**CALIFORNIA COASTAL COMMISSION**

**STAFF REPORT:**  
**PERMIT AMENDMENT**

**APPLICATION NO.:** A-1-MEN-01-043-A1

**APPLICANTS:** KEN AND JILL ROOST

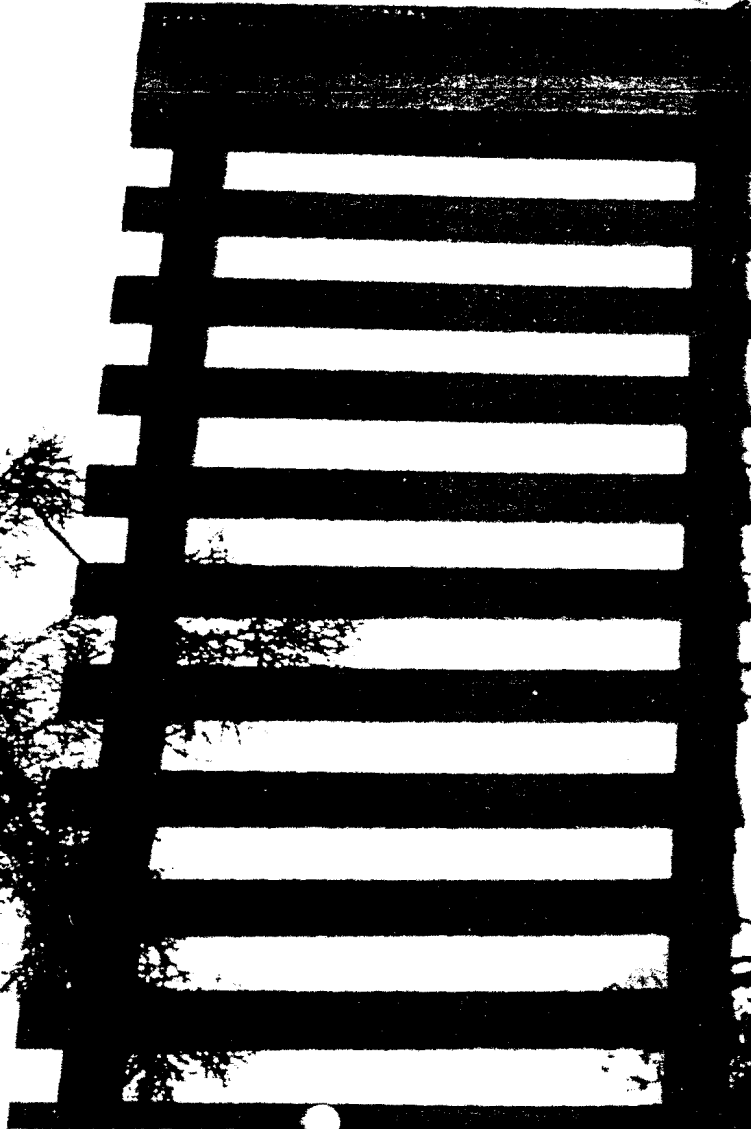
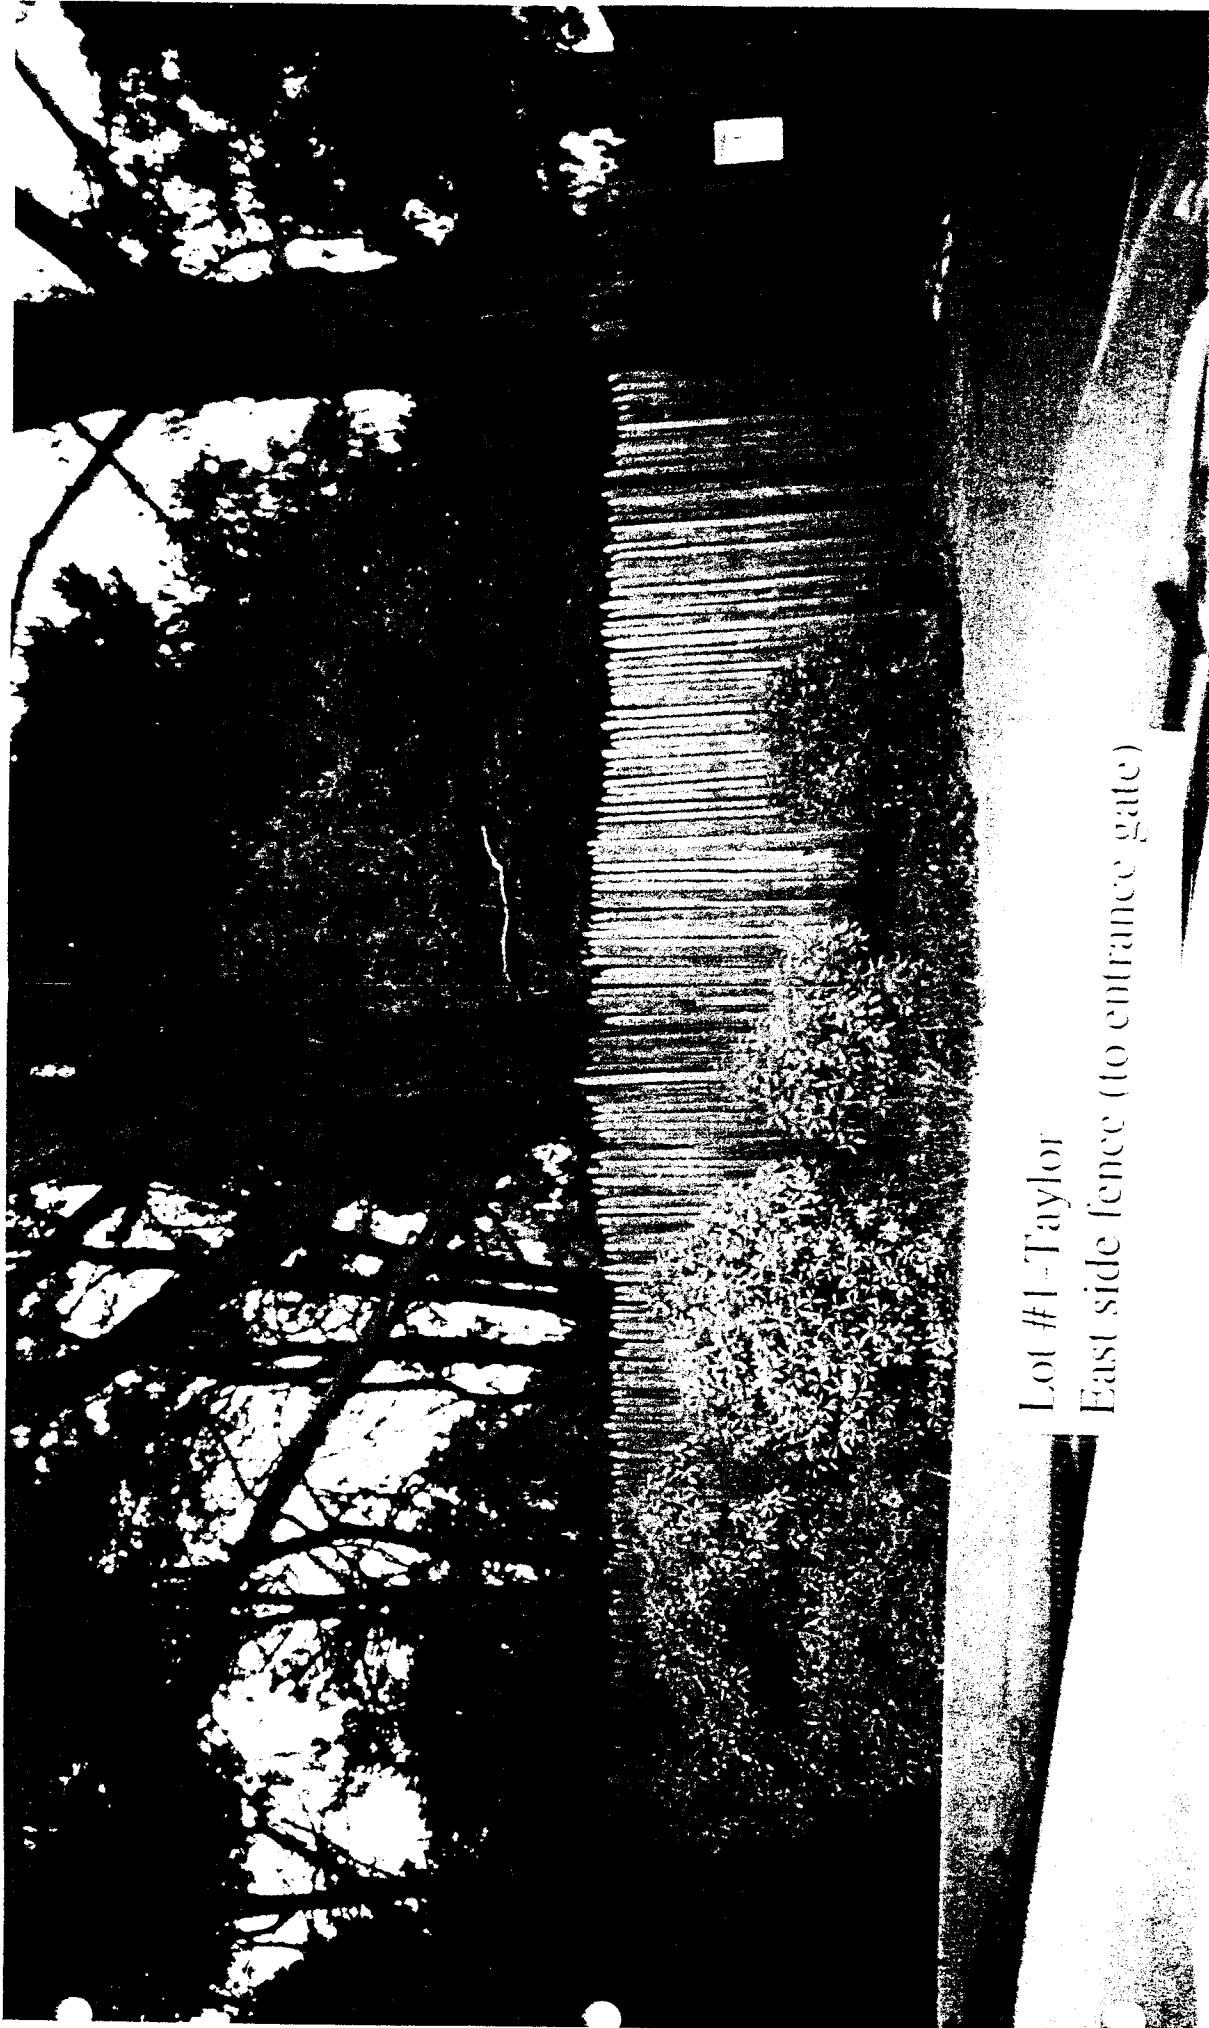
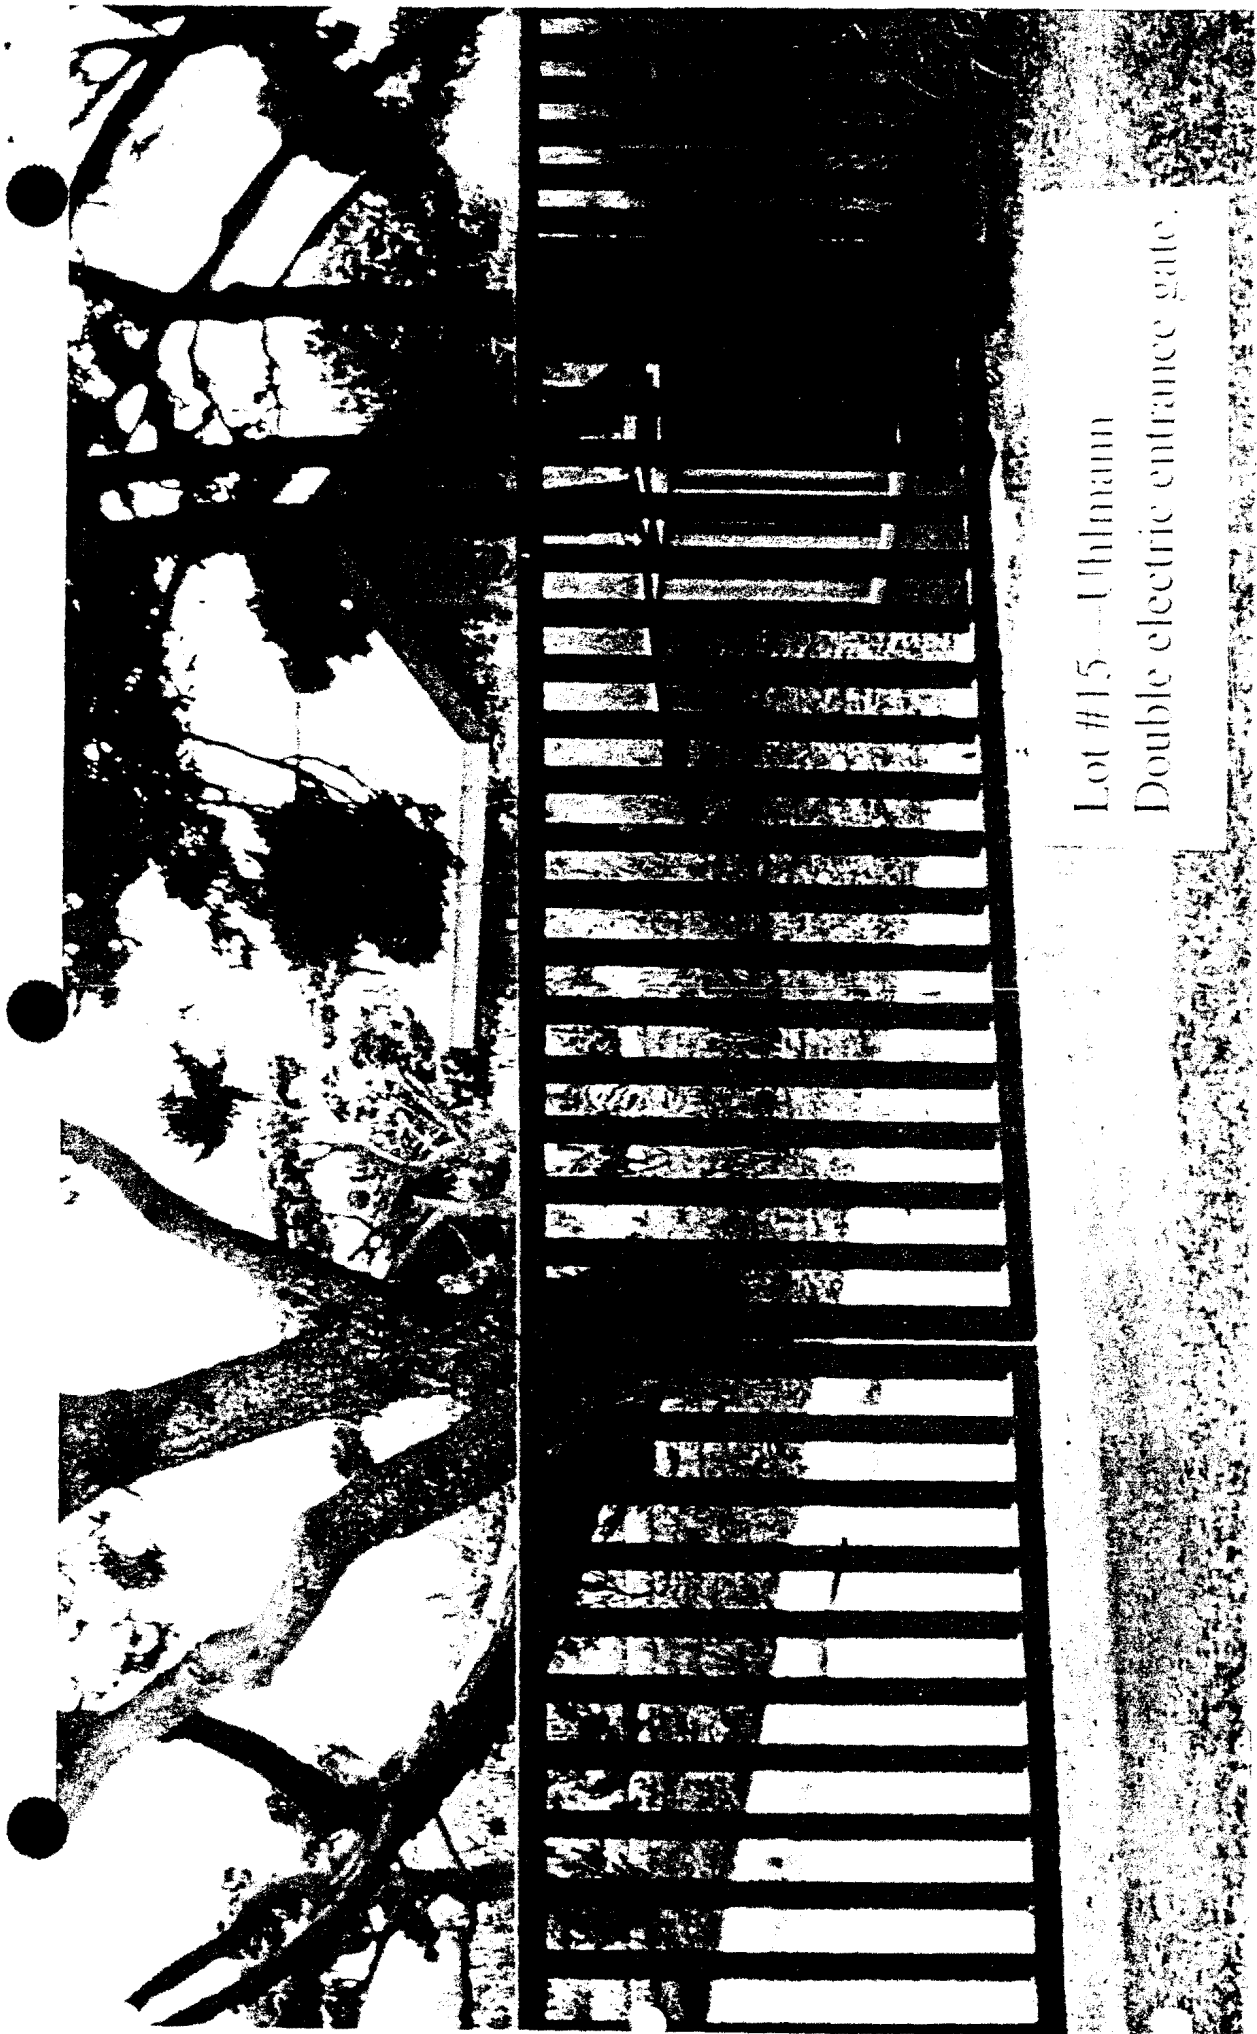
- As the proposed fencing would make a substantial contribution to the exterior appearance of the proposed residential improvements at the site, supplementary information is needed so that we may conclude that the fencing would be compatible with the similar surrounding development. Please provide an addendum to the compatibility study detailing the types, heights, and extent of fencing on other lots within the Little River Headlands Subdivision neighborhood. In addition please indicate what if any existing vegetation may exist in proximity to the proposed fencing and how that vegetation might screen or soften the appearance of the fence within those areas on the parcel visible from public vantage points (see Exhibit No. 11 of the November 22, 2002 revised findings staff report).

RESPONSE: Addendum to compatible study. I have enclosed a number of colored photographs enlarged to 11" X 17" that show the fencing within the Little River Headlands Subdivision. Almost all of the lots have single family residences. The Langer's are currently under construction of their SFR on parcel 2. Parcel 6 is owned by Glen Ricard and does not contain a residence but is fenced on all three sides. It has been used as a site for a horse. Lot #14; Uhlmann contains the septic system for Uhlmann's residence on Lot #15. The only Lot not built on in the subdivision is the Roost Lot #10. This past week I visited the subdivision and inventoried the fencing. As you know there is a metal sliding entrance gate that is approximately 20' across. Adjacent to the gate is a pass through pedestrian gate. These gates are approximately 6'-8' high. Around the entrance gate is approximately 380' of fencing. Of this 380 feet of fencing approximately 280' is solid 6' high grape stake fencing. The other 100 feet of fencing is approximately 4' high with 2"-3" spacing between the boards. There is no fencing around lots 1-4 that are on the north side of Headlands Drive. Lots 5, 6, and 7 are fenced on all three sides right to the bluff. Most of the fencing is 40" high. There is fencing on the east side of the Tower lot (8) and a small amount of fencing on the Burke parcel (9). There is fencing on the east side of the Weikel property (11) and on the east side of the Abramson parcel (12) This is solid fencing 6-7" high that runs approximately 40' in length. Lots 14 and 15 (Uhlmann) are fenced in the front. The fencing is approximately 3 1/2 feet high. The Calof parcel has a low fence along the street which is about 2' high. All the fencing is shown on the Map marked #3... The whole subdivision contains a substantial number of pine trees. The subject parcel lot #10 has 8 pine trees on the north side that are 15-40' in height. There are 13 trees on the east side that are from 5-15 feet in height and there are 6 trees on the west side adjacent the Weikel property line that are 20-50' in height... All the trees are pine.
